DRAFT: 1109 Bathurst Street

Project Name: 1109 Bathurst St. ¹	Date of Application: 24 June 2020
Application Number: 20 159922 STE 11 OZ	Date of ARA Board Approval of this Position Statement: 9 September 2021
P+D² Draft recommended to Board on: 7 September 2021	P+D Review Group: David S., Terry M., Lynne D., Henry W.

Brief Description of Project

Architect's rendering looking north-east

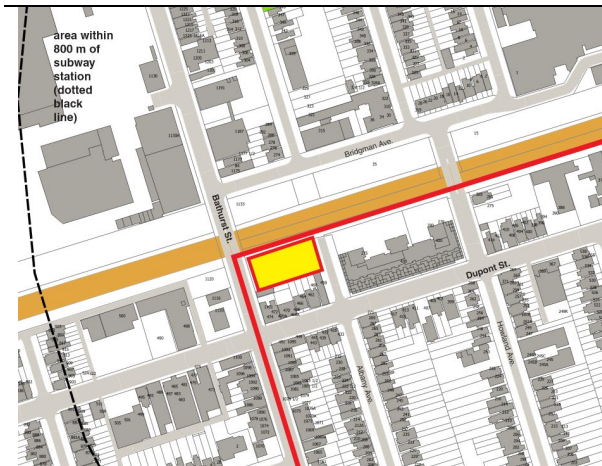
- The proposed building height, although still at 9 storeys, is now mitigated by step backs on both the Bathurst and Albany elevations, which reduce the massiveness of the building. Although 8 storeys or lower is preferred, the current proposed height, including the penthouse, is 32.3 m (top of mechanical penthouse) lower than the Bianca at 37.97 m, east of the site on Dupont.
- The floor levels are now expressed and glazing with single loaded corridors are provided on the Bathurst and Albany facades. The aforementioned step backs improve the relationship between the top two storeys and the remainder of the building.

- The shadow impact to the north is now partially reduced by virtue of the aforementioned step backs. Trees are now proposed along both Bathurst and Albany. Increased set backs on both the east and west elevations make this possible.
- Re: Impact of noise/vibration from trains (C P Rail). A noise study and peer review are in process. However, the use of rough brick cladding to dissipate noise has

now been proposed, although the question remains as to how high the cladding will go given the elevated track bed.

1. Remove the proposed windows to the storage rooms on the south facade. They are gratuitous and inappropriate.
2. The base (lower two floors) of the south facade should be masonry, matching that of the north facade and creating a more robust and durable wall in anticipation of a possible future light well.

3. The proposed glazed bay on the Bathurst facade is out of scale. The bay should be removed and the design of the Bathurst facade should more closely resemble that of the Albany facade.
